From: Anna Kramarczyk <Anna.Kramarczyk@midsussex.gov.uk>
Sent: 03 December 2025 13:03:00 UTC+00:00
To: "Katherine Williams" <Katherine.Williams@midsussex.gov.uk>
Subject: RE: DM/25/2283 and DM/25/2472 - Queen Victoria Hospital, Holtye Road, East Grinstead

From: Sophie Hulton-Harrop <Sophie.Hulton-Harrop@mottmac.com>
Sent: 02 December 2025 13:46
To: Katherine Williams <Katherine.Williams@midsussex.gov.uk>
Cc: Tim Butcher <Tim.Butcher@mottmac.com>
Subject: RE: DM/25/2283 and DM/25/2472 - Queen Victoria Hospital, Holtye Road, East Grinstead

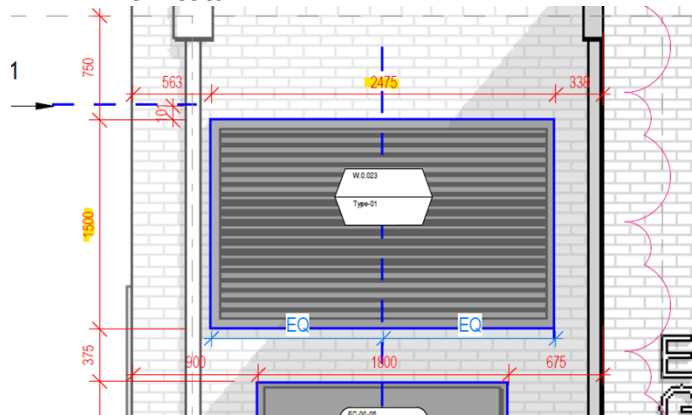
Regarding the updated louver design, please see more detail below.

The areas previously considered for the louvers were:

- **East side (square opening):** 3.44 m²
- **West side (rectangular opening):** 5.40 m²
- Total:** 8.84 m²

Due to clashes with columns and MEP minimum opening requirements, we are now proposing similar-sized openings for both locations:

- The new updated landscape plan is missing the key for the *Balustrade with Handrail Metal railing installed along the access path, including ramp and stair areas. Powder-coated finish (PPC) in RAL 1019*. Can this be clearly annotated.
- Regarding **Louver design** - *changed due to clashes with the structural grid, identified at detailed design stage. The dimensions of the louvers have changed slightly to accommodate the position of the structural columns and other building fabric elements.* Can I ask to describe 'slightly' in some numbers so I can get a better understanding of the scale of impact of this change.

- **Each opening:** 3.72 m²
- New total:** 7.44 m²

Please can you confirm that this change would constitute a Non-material Amendment and therefore a S96a application can be submitted?
